Submission on Proposed Plan Change 7 – Rotokauri North Private Plan Change

Proposed Plan Change 7 Submission

Figure 15 -7a

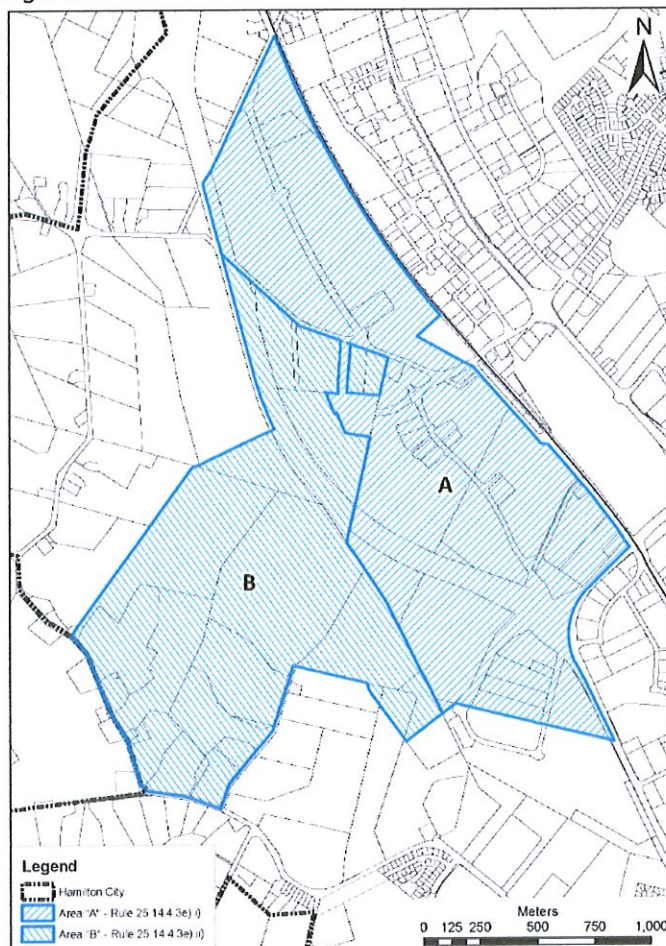
The proposed plan change is inconsistent with structure plan component *“3.6.3.2 Roading”* in its entirety. The proposed area is within the stage 2 area, outside of Areas A and B (see Figure 15-7a). The Rotokauri Structure Plan indicates that the release of land beyond stage 1A (such as the PPC): *“will be contingent upon the availability of network capacity which may arise as a result of traffic generation”* and 3.6.2.3 d and e) provide that:

Proposals for the development of land in ‘Area B’ on Figure 15-7a will require careful scrutiny to ensure that adequate network capacity exists to support the development, or will be provided as part of the development and they will not compromise the development of land in ‘Area A’ on Figure 15-7a. Development will require:

e) The development of land outside Areas 'A' and 'B' (Figure 15-7a) will need to coincide with the northwards extension of Rotokauri Minor Arterial Road to connect with Te Kowhai Road at the City Boundary.

The PPC is clearly contrary to these provisions, and the developer is trying to dodge the full cost of developing ahead of the planned sequencing by exempting itself from these Rotokauri Structure Plan provisions. The PPC does not provide adequate transport network capacity outside of the PPC area to support the proposed development. The proposal does not achieve a sustainable expansion of the city and does not represent coherent and integrated development, because the transportation effects beyond the Rotokauri North boundaries have not been resolved.

- Either decline the private plan change; or
- Decline proposed inclusion of section 3.6 d (exemption of PPC area from Rotokauri Structure Plan), but approve the development subject to requiring the developer to adhere to all existing Rotokauri structure Plan provisions, including:
 - a) requiring they construct the Rotokauri Minor Arterial Road;
 - b) provide an ITA that adequately assesses impacts on the wider transport network and have that ITA peer reviewed.
 - c) cater for the demand generated within the wider transport network;

- d) requiring the developer to fund all necessary road network upgrades and additions.
- e) provide a full economic assessment of the financial impact on the remainder of the Rotokauri Structure plan area and including the likely cost of the required roading upgrades.
